REQUEST FOR INFORMATION

GENERAL INFORMATION		
Project Name:	Saranac Lake Gas Co. OU02, OU03	RFI No.: 01
Project Location:	Saranac Lake Village Saranac Lake, New York	Date Information Requested: 3/20/2018
		Date Information Required: 4/16/2018
Client:	NYSDEC, Site No. 516008	Date Information Provided: 04/25/2018
Contractor:	LAND Remediation, Inc.	RFI Results in a Field Order or Change Order:
MACTEC Project No.:	3611181219	☐ Yes, FO No. ____ ☐ Yes, CO No. ____ ☒ No

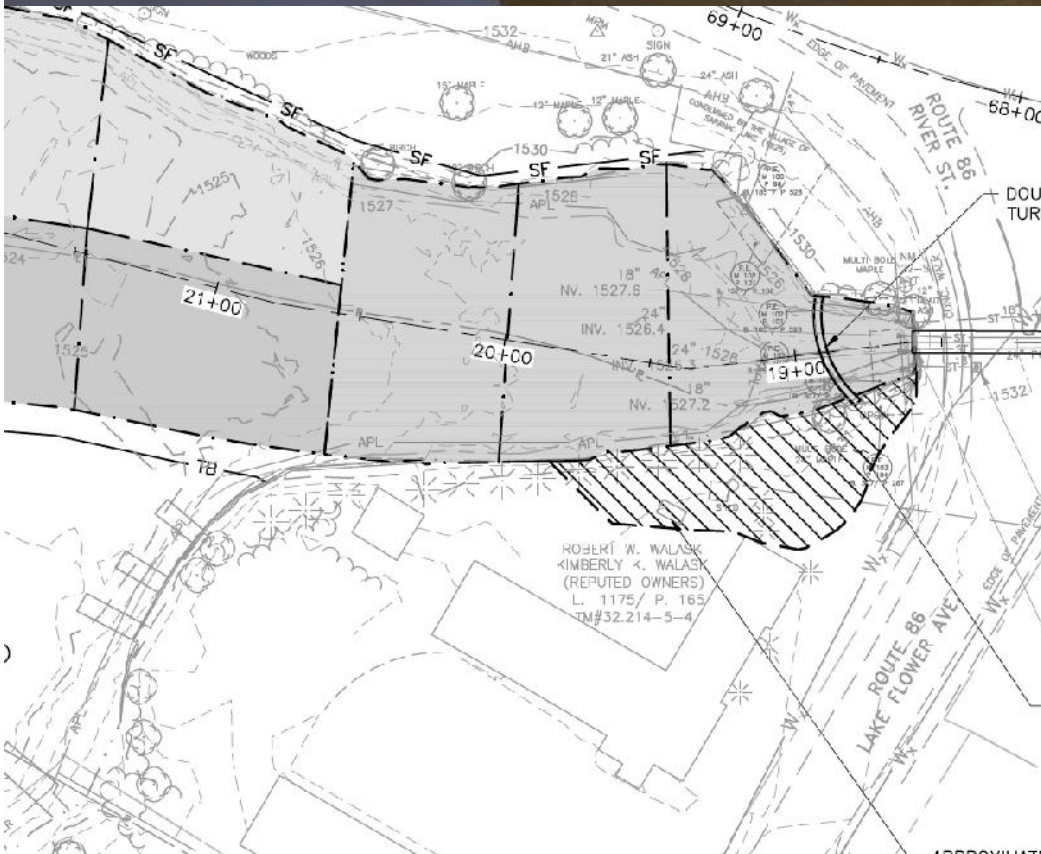
Land Remediation Inc (LRI) has observed a concrete retaining wall at the southern dredge limits. The wall is at risk of structural failure if a vertical cut is taken to start the slope directly adjacent to the wall as shown in the provided dredge surface. LRI requests a revised dredge surface detailing the required sloping around this structure to ensure it's stability while meeting design criteria or a designated offset to safely remove the required sediment without causing damage to the wall or undermining it's structural stability.

1. Prior to full scale dredging at wall, conduct investigation to see if the wall has a footing.
2. If a footing is present, conduct dredging in accordance with Detail S on drawing C-304 except provide a 2-foot offset from footing.
3. If no footing exists, provide 2-foot offset from wall and dredge down with 3:1 slope.
4. During dredging operation, if evidence of MGP waste – odor or sheen – is observed, the demarcation/barrier layer will be placed if directed by the Department and Engineer.

FIGURE 1.

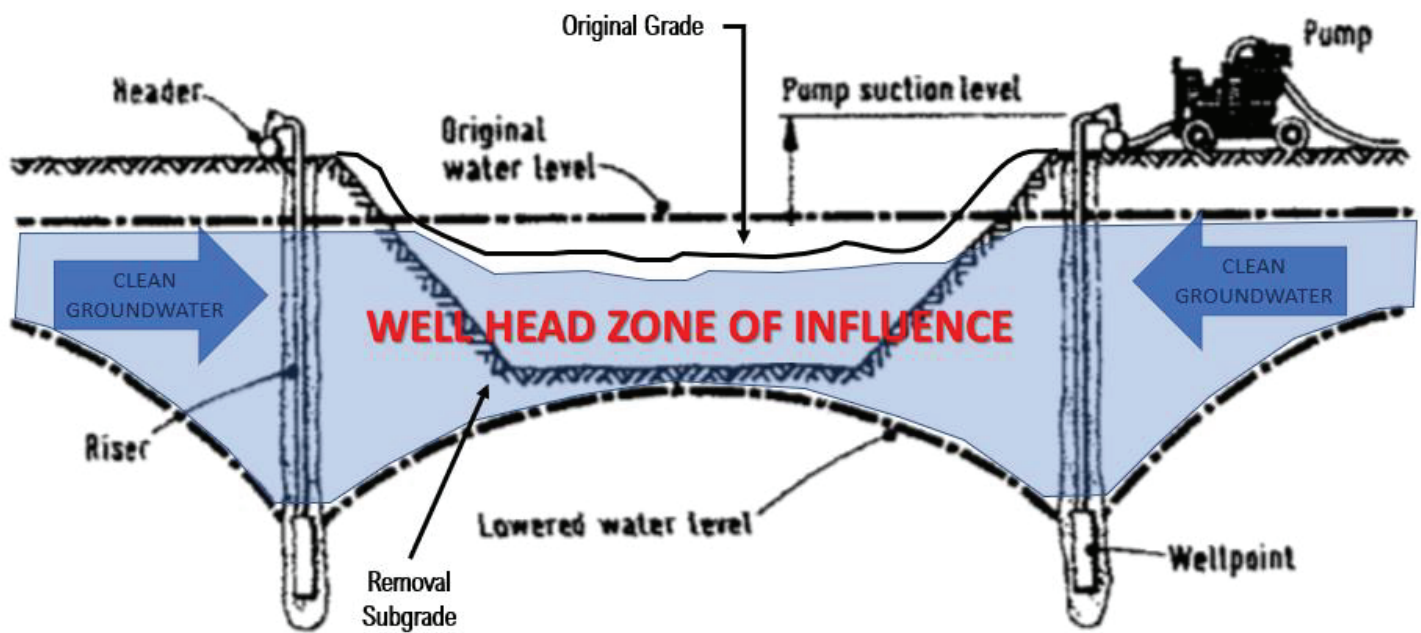
- a. Once the initial drawdown is completed and the localized water table is dropped to below the excavation sub-grade, only the "clean" surrounding groundwater will be collected from the system (Figure 1.)

RFI Received By: Mark Stelmack	Initial: MJS	Date: 7/31/18	
MACTEC Response: Based on review of available groundwater data in the area, and various correspondences on the subject among the project team, the request to discharge well point water without treatment is denied. Well point water shall be treated at the OU2 water treatment facility prior to combining with the bypass water and discharged to the brook. Sampling shall be conducted per the discharge permit.			
MACTEC Review:			
Individual	Discipline	Initial	Date
M. Stelmack, PE	Project Manager	MJS	8/7/2018
M. Peters	Remediation Engineer		
J. Welch	Remediation Engineer	JDW	8/7/2018
T. Lewis	Resident Inspector

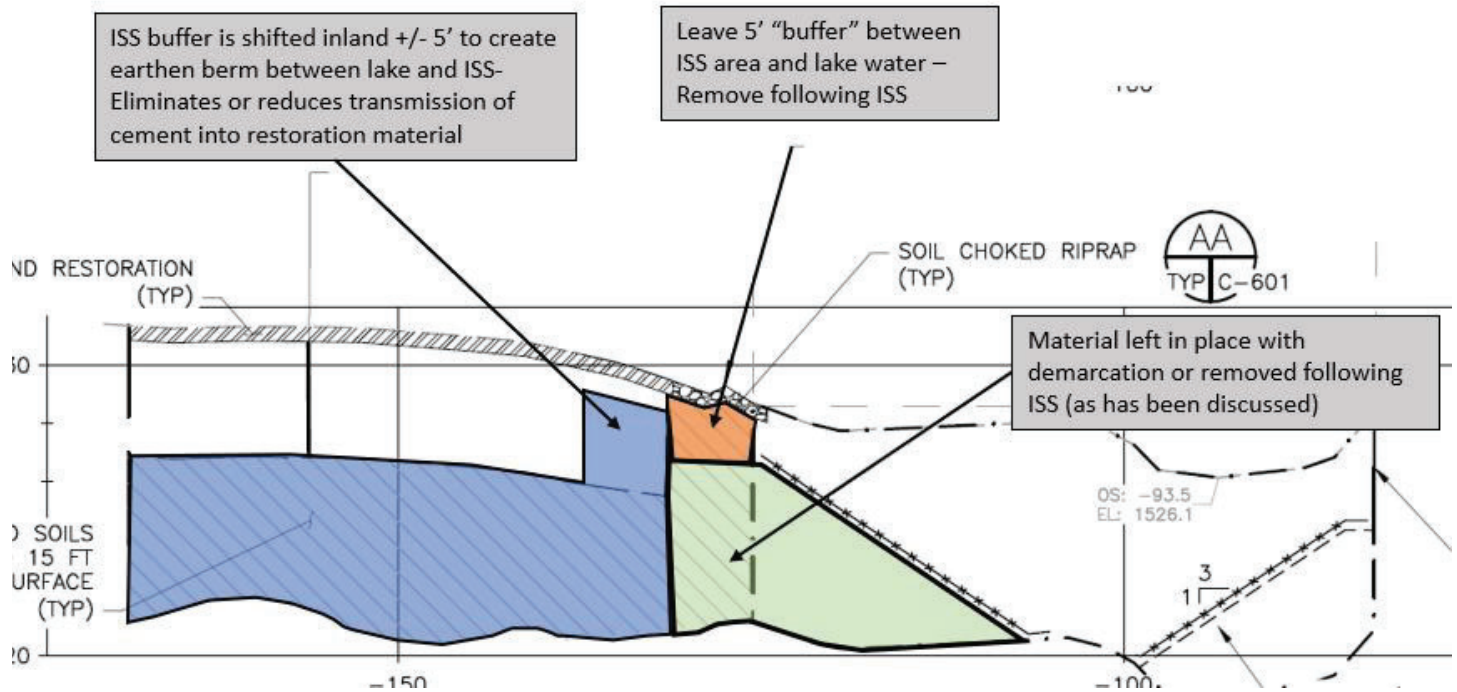
REQUEST		
Information Requested: The purpose of this RFI is to inquire on the possibility of moving the lakeside extent of the ISS inland by +/- 5-7'. The "wedge" of material forming the buffer would be removed following the ISS. This change would address a few items; <u>Cedar Row:</u> The cedar tree root systems are directly in the footprint of the lakeside edge of the ISS as designed. These would have had to be removed prior to mixing in that area regardless. Root removal would likely bring removal of the "wedge" soils as well. - With this approach, the root area can remain in place as the buffer and removed following the ISS <u>ISS Transmission:</u> create a buffer between the newly placed backfill and ISS operation - As designed, the ISS is to be mixed directly abutting the very granular bay backfill. - leaving this buffer would provide a better chance of stopping any sub-surface transmission of the cement slurry into the newly placed backfill/ habitat fill.

RESPONSE			
RFI Received By: Mark Stelmack	Initial: MJS	Date: 8/27/18	
MACTEC Response: Based on the discussion of this approach on 8/23/18 with NYSDEC, Land Remediation can proceed with this approach. The wedge of material in front of the finished ISS area is to be left in place and not removed.			
MACTEC Review:			
Individual	Discipline	Initial	Date
M. Stelmack, PE	Project Manager	MJS	8/31/18
M. Peters	Remediation Engineer

SARANAC - OU3 ISS AREA

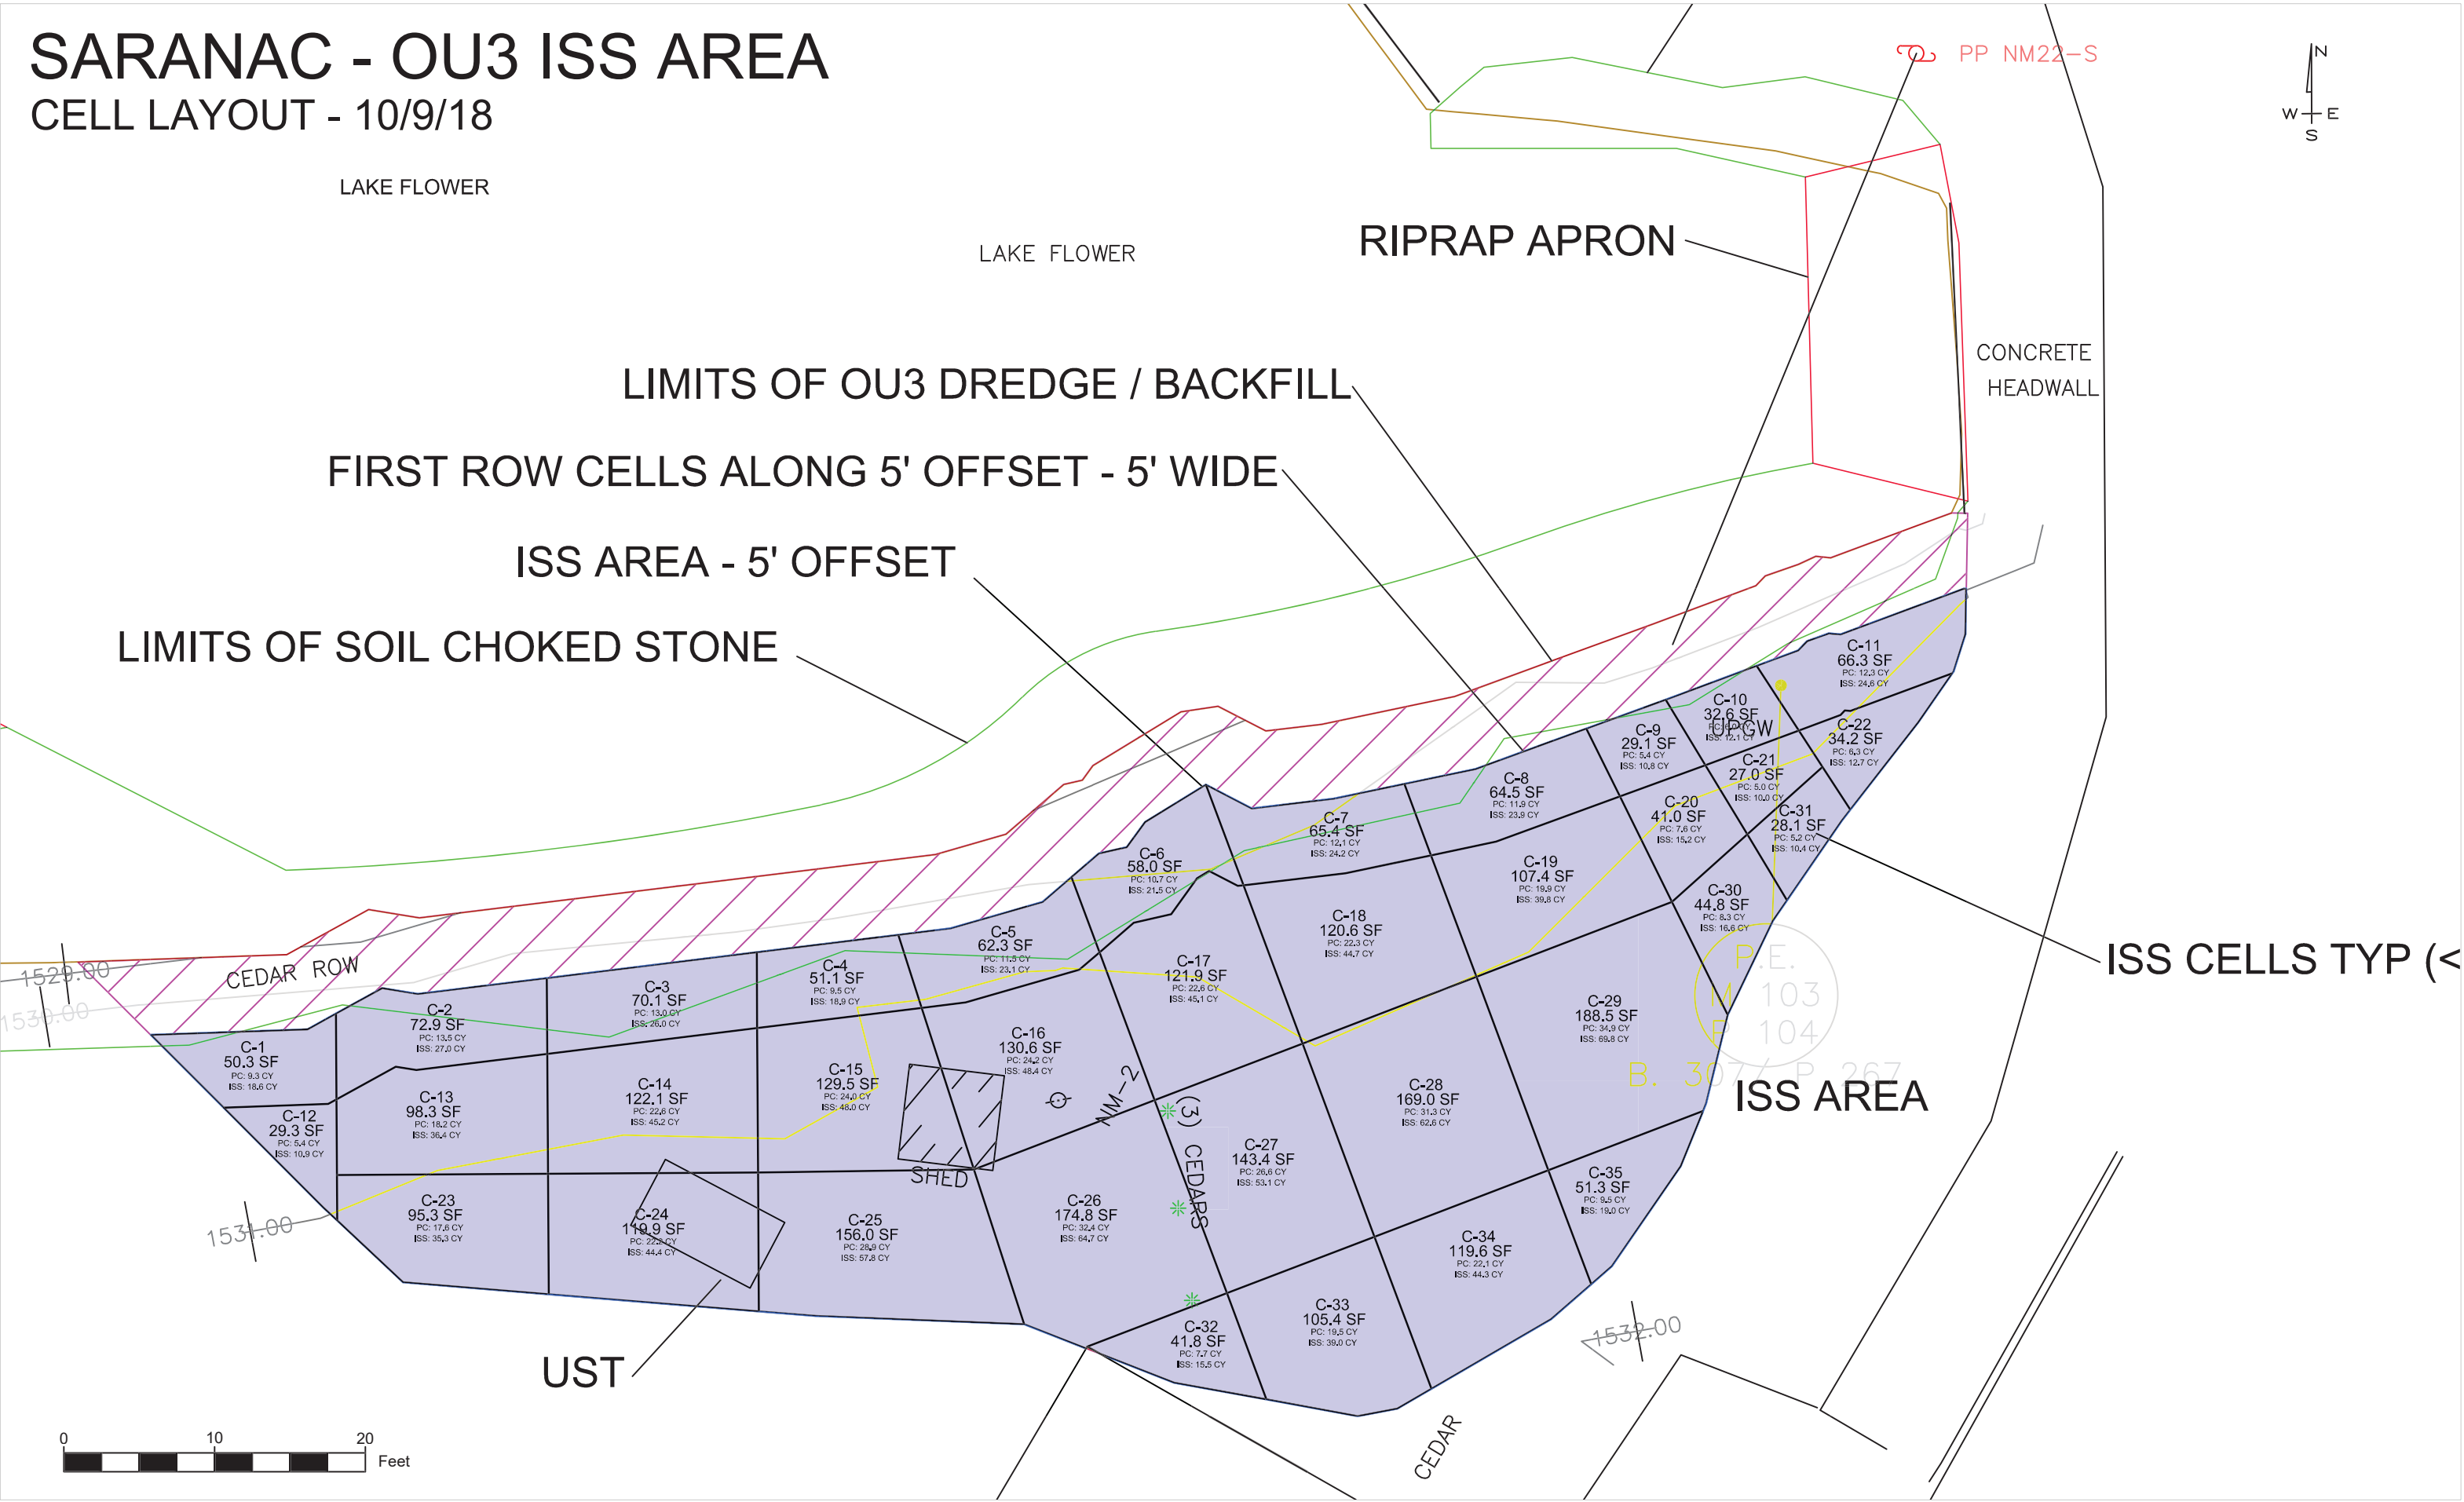
REQUEST		
Information Requested: The purpose of this RFI is to request approval of a change from the specified auger mixing to skeleton bucket mixing methodology in the In-situ Stabilization area.		
After occupying the site and based on further review of the alpine mixing equipment detailed in the construction work plan coupled with the high water levels, LAND Remediation contends that a more even and thorough mix can be achieved using reagent dry placement and bucket mixing. Issues we foresee with the Alpine Mixer are as follows; • The Alpine mixer is most effective when utilized with a pumped grout mixing technique which is not suitable with the conditions and levels of the site water table. Adding a 1:1 water to cement grout mix will jeopardize the ability to achieve the strengths required. • Since submitting the work plan, LAND has experienced less than favorable results with attempting to inject “dry” cement into the mix using the Alpine mix unit. • The mixer would need to be attached to a 400 size excavator and a support excavator would be required as well. This leaves very limited space with the pre-cut, lake, road, equipment and existing structure impeding access. With the spacial constraints and loose sand soils in the ISS area, LAND believes the placement mechanism of supersacks and mixing with the skeleton bucket will produce; • By utilizing the skeleton bucket, a more vertically homogenous mix will be attained. Previous experience utilizing this method will blend provides a more homogenized mix within the treatment zone by the shearing action of the skeleton bucket in the soil column • Utilizing the skeleton bucket will enable LAND to hold the original schedule. Meeting performance standards is the responsibility of LAND and based on previous ISS experience where this method has been utilized on multiple MGP sites, this change in means and methods will afford the best option to achieve passing strength requirements.

MACTEC Response: Based on the additional information provided (Cell Layout Plan and PC quantity calculations) as well as LAND's responses to the questions below, MACTEC approves the modified mixing approach for the ISS. In addition, MACTEC approves a ten-foot buffer between the water's edge and the ISS area, as visual observation of the initial soil excavation in the ISS area indicates that a five-foot buffer would likely fail structurally and collapse.
